Skye Canyon Parcel 2.16

1st Submittal

CITY OF LAS VEGAS INTER-OFFICE MEMORANDUM		DATE: November 29, 2016
TO: Land Development Services Department of Building & Safety		FROM: Albert Sung, P.E. Flood Control Project Engineer Department of Public Works
SUBJECT:	Drainage Study for: Skye Canyon Parcel 2.16	
Cross Streets:	NWC of Egan Crest Dr. & Eagle Canyon Av.	COPIES TO: Slater Hanifan Group
File Number:	F:\Depot\DSMemos\DS4842A.doc	Section 12, LLC / Ninety Five Mangt.
Parcel Number:	126-12-000-001	Bart Anderson, P.E., DevCo
Zoning Action:	TMP-65809	CCRFCD
FEMA Flood Zone	YES	NO X
Proposed Storm Drain	YES	NO X

The Drainage Study for the subject project has been reviewed and:

G-4
SHEET 7 OF 11

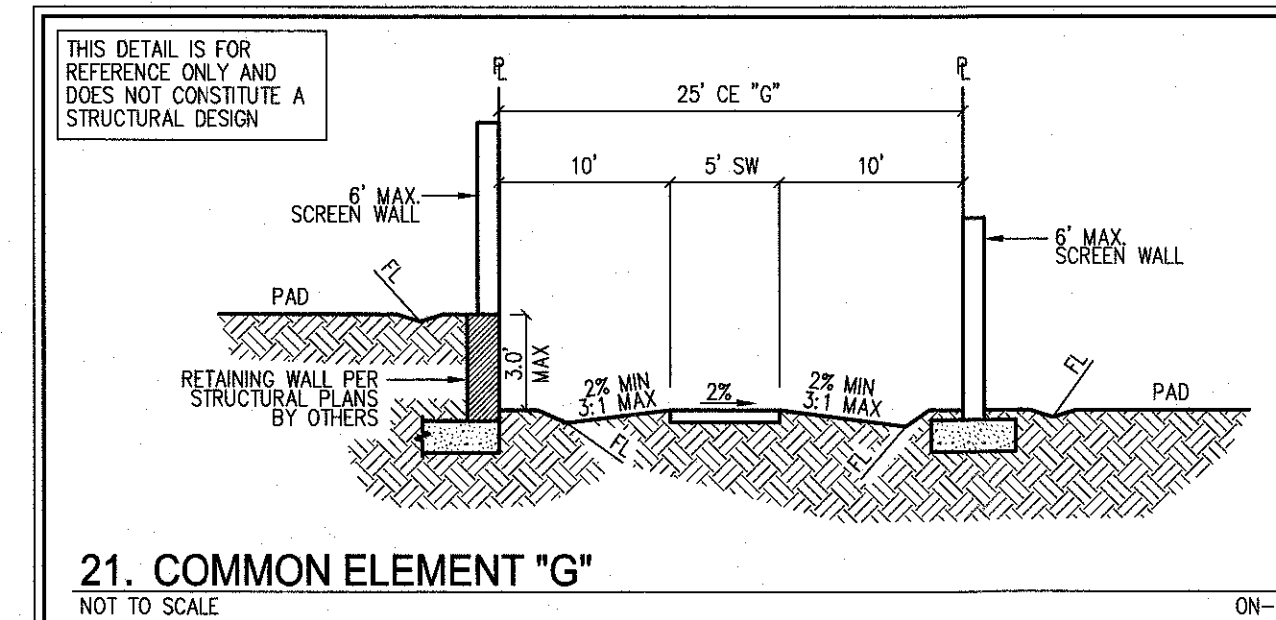
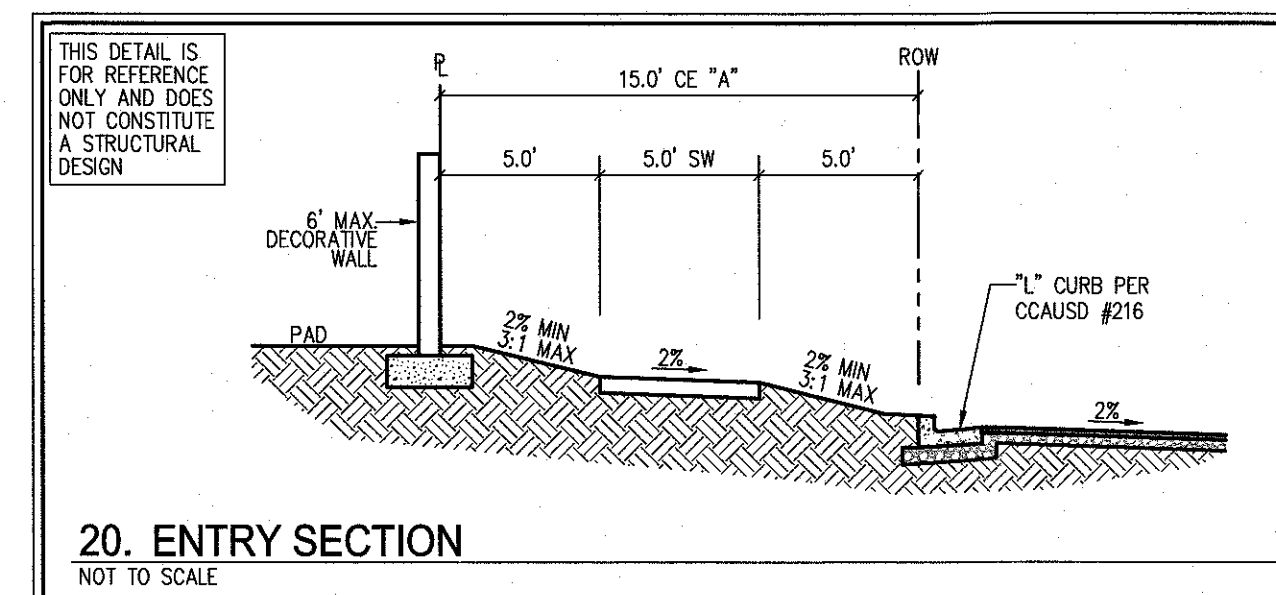
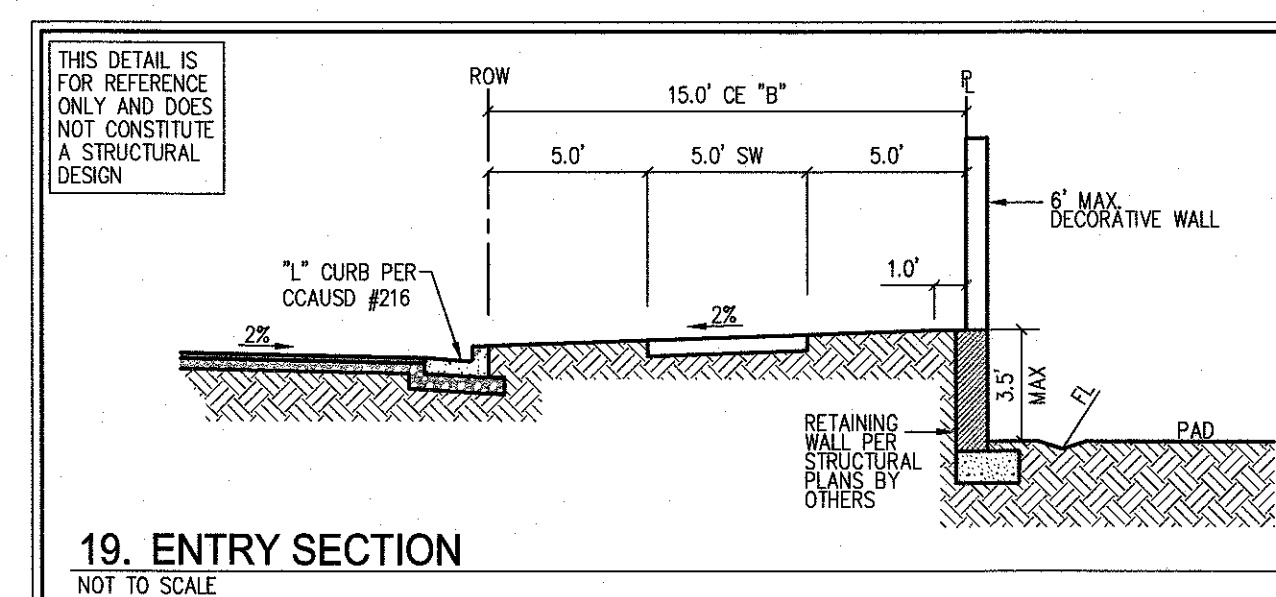
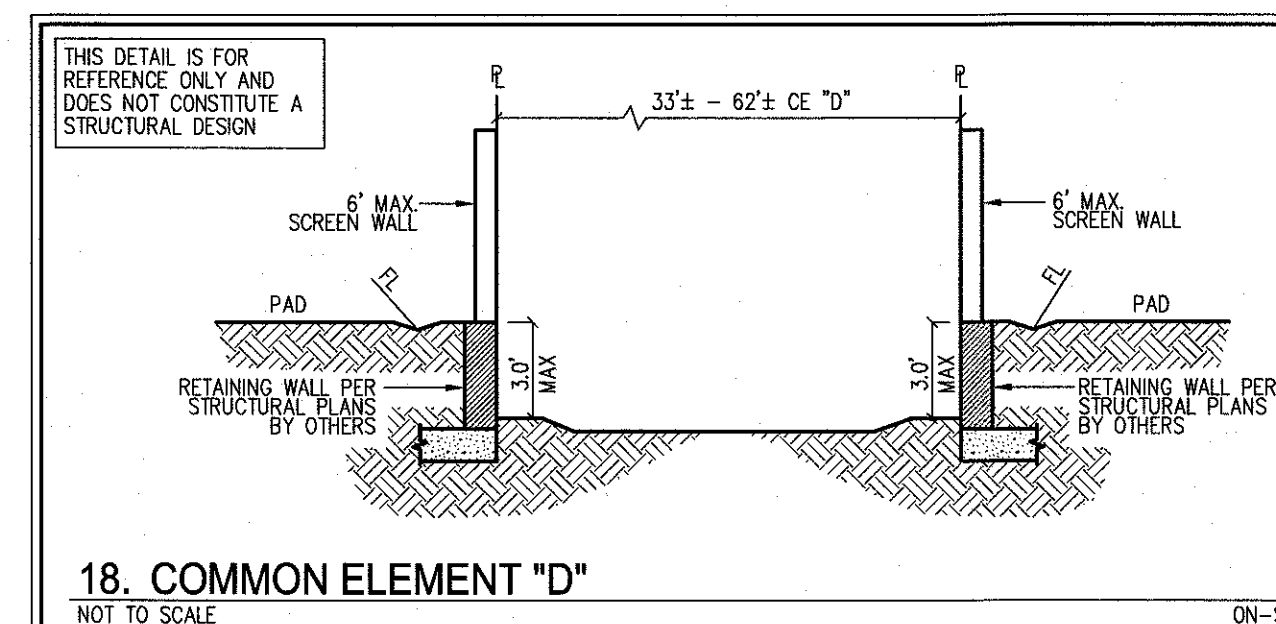
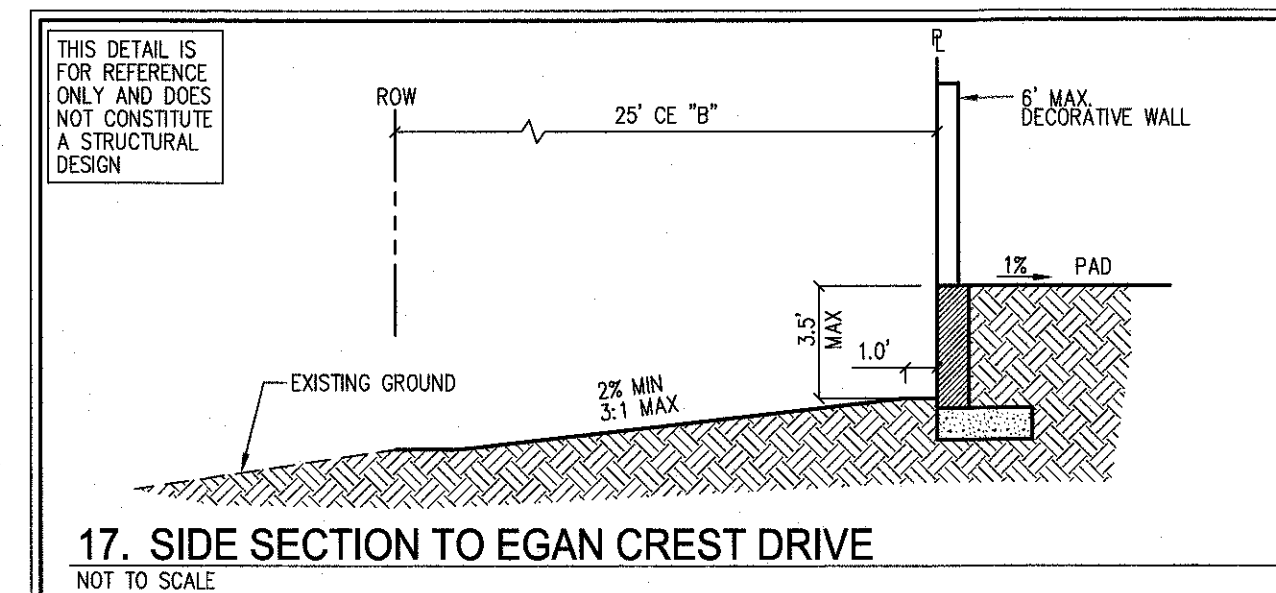
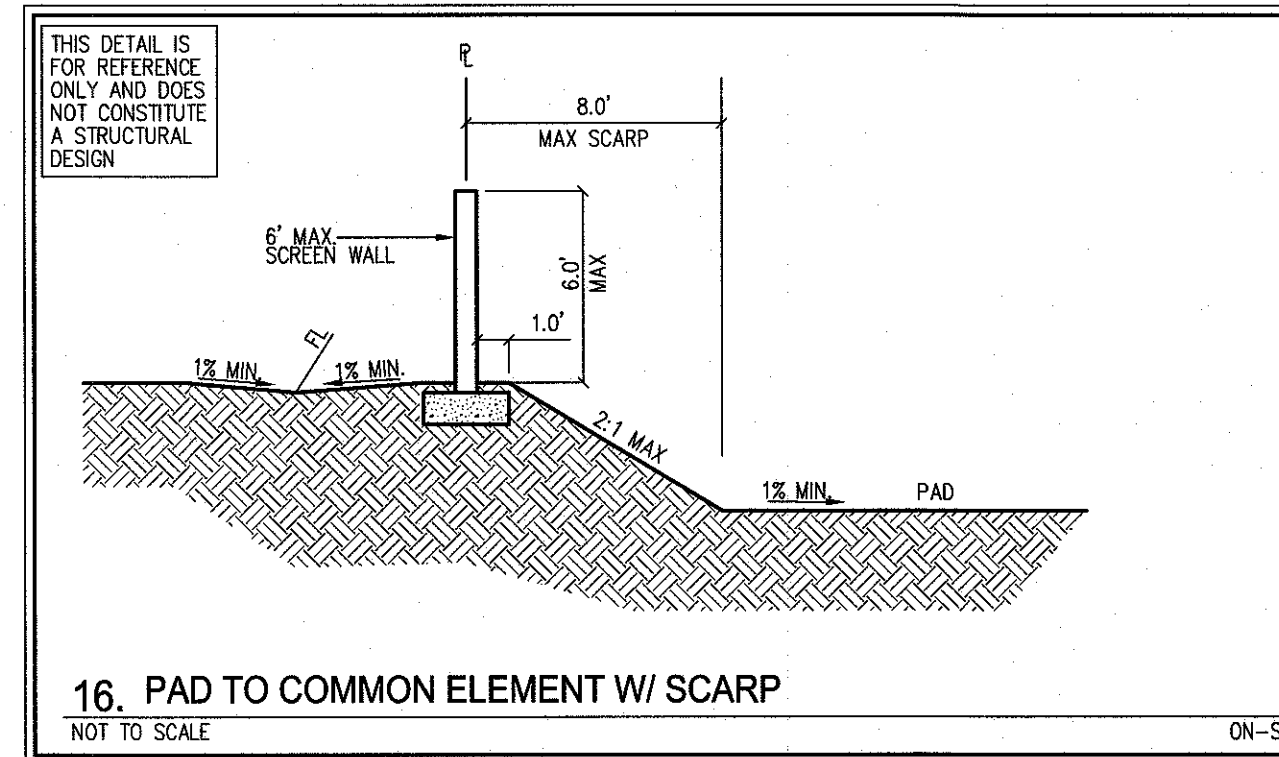
It appears that ***Parcel 2.16*** will be developed after ***Parcel 2.15*** adjacent to the east of ***Egan Crest Drive***. Show developed condition of ***Parcel 2.15*** on **Sheet G-2** and **Sheet G-4**.

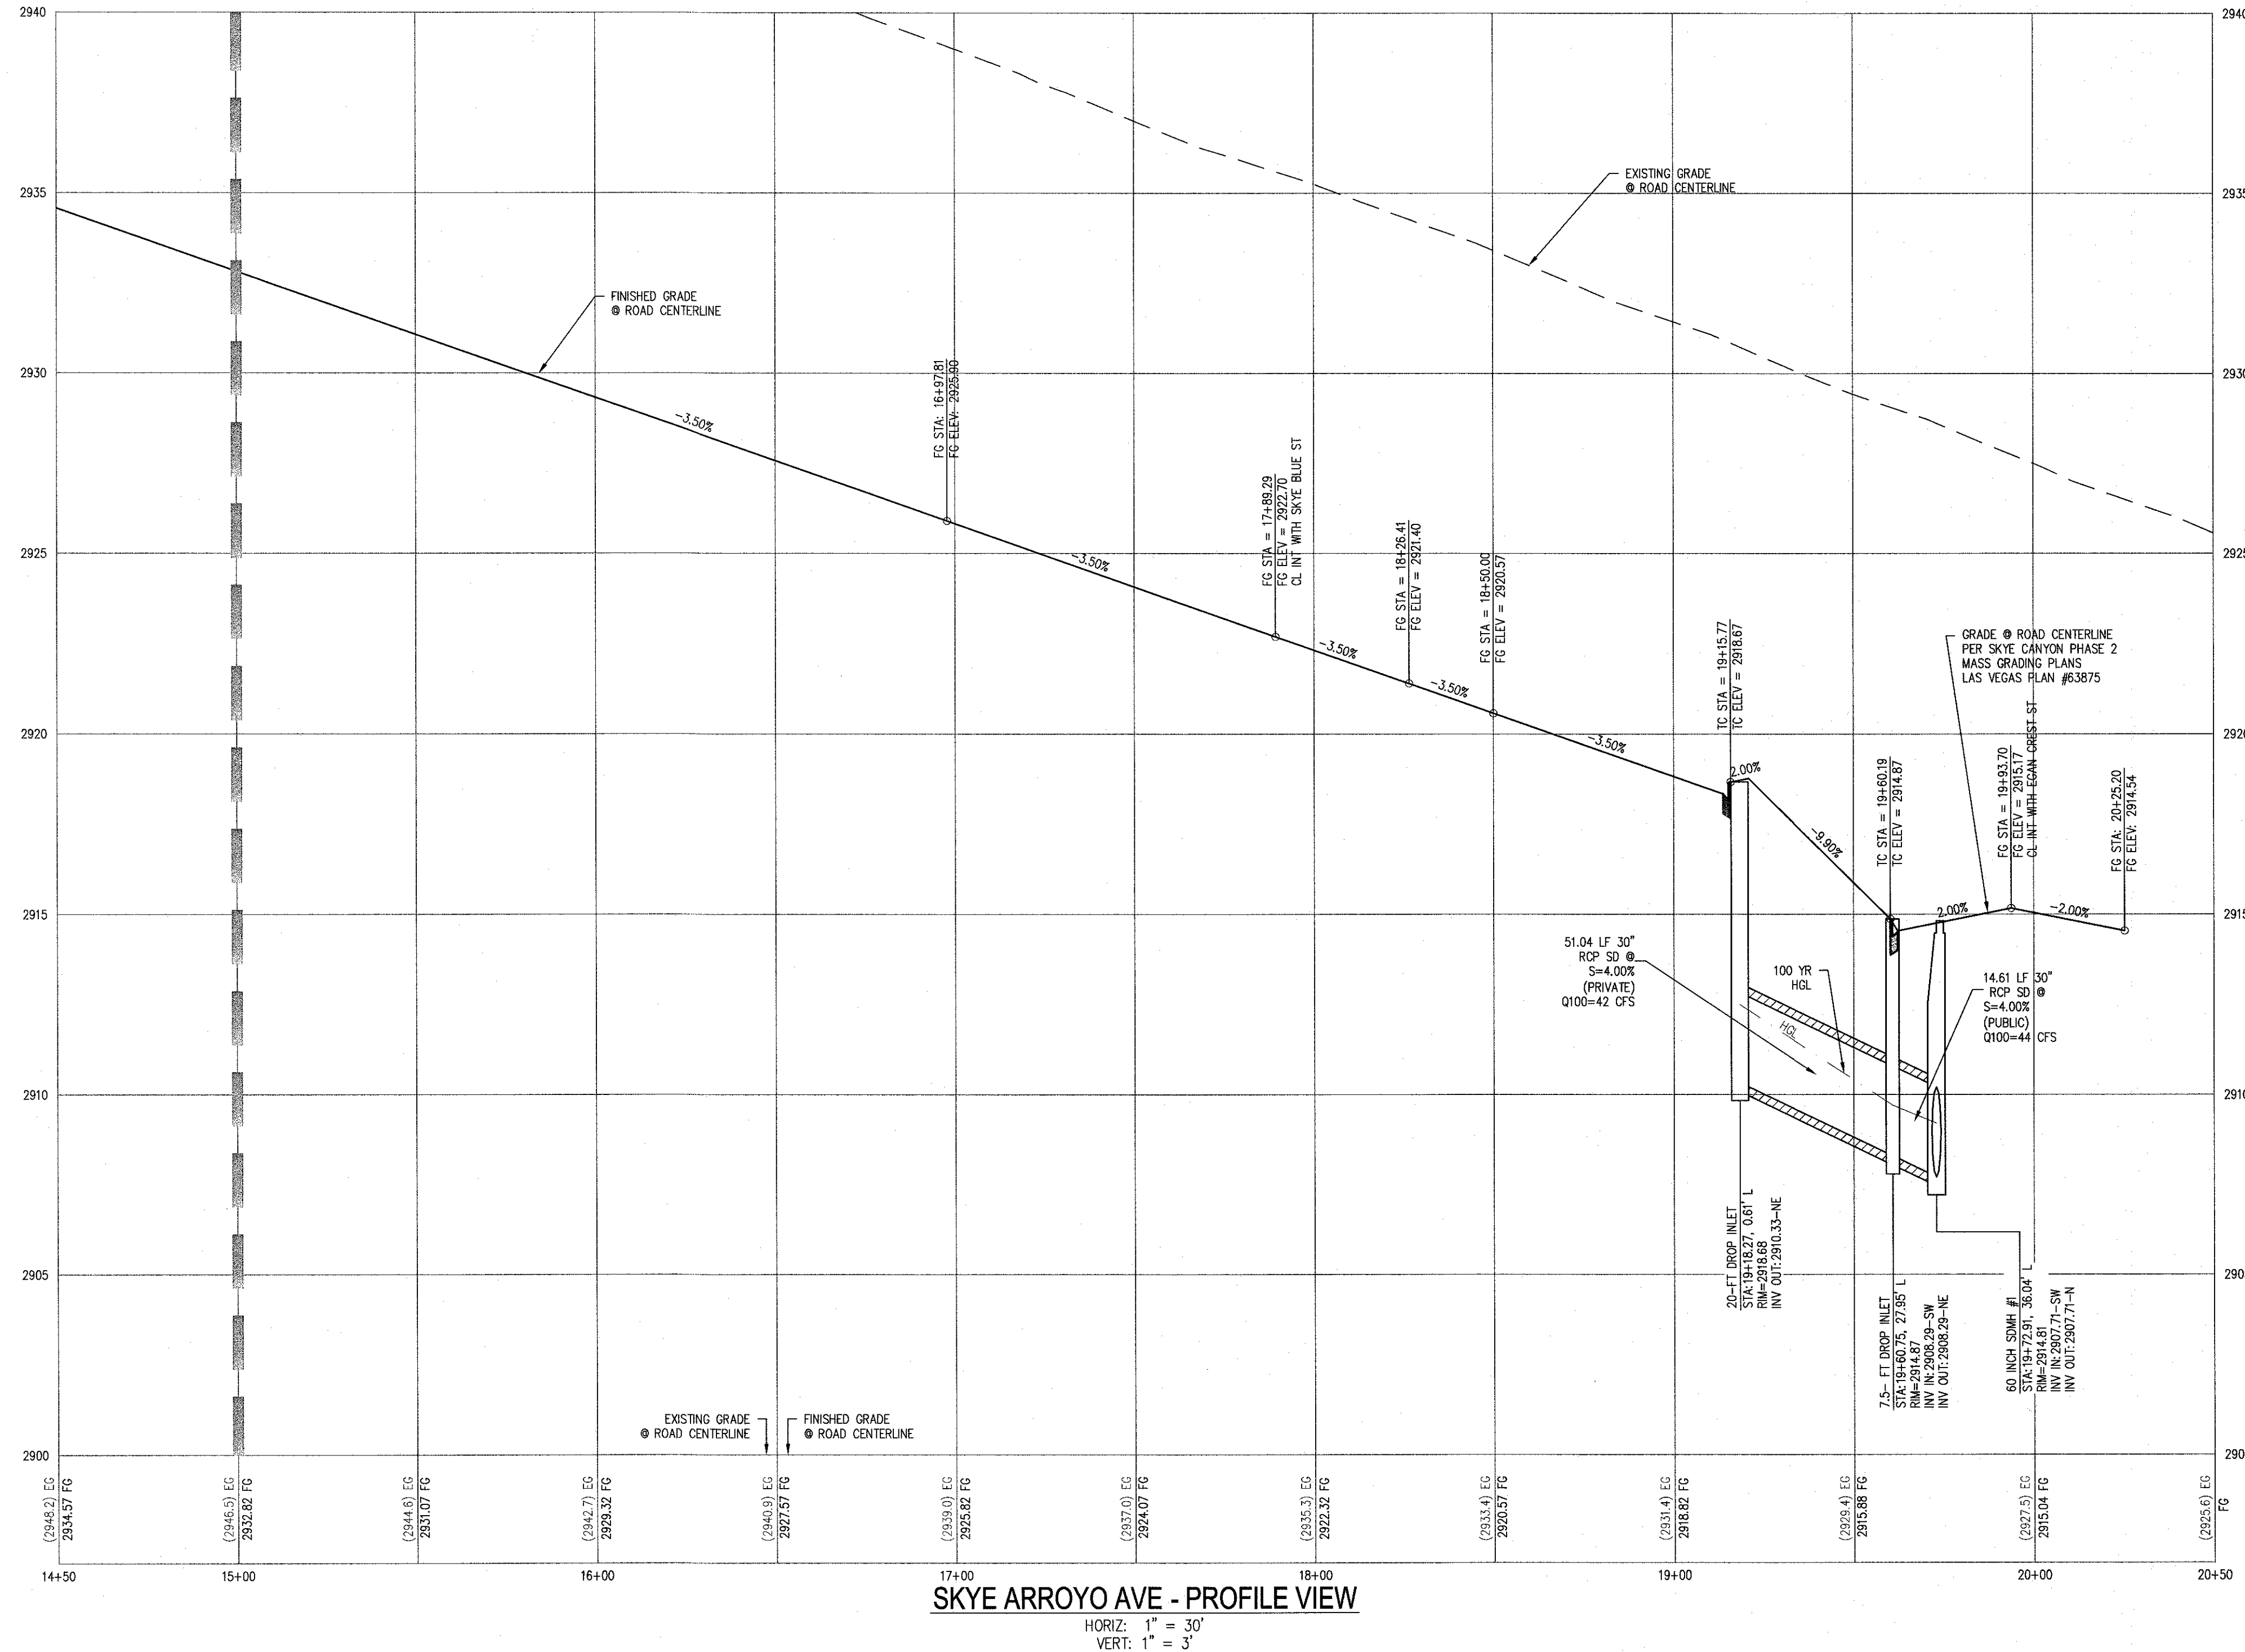
14. Revise all callout of proposed drop inlets to include only the length of the inlets without adding the number of grates. There were projects constructed in which the contractors followed only the number of grates without double checking the total length whether matching the length callout. Shorter inlets were constructed as a result. Review and revise accordingly.
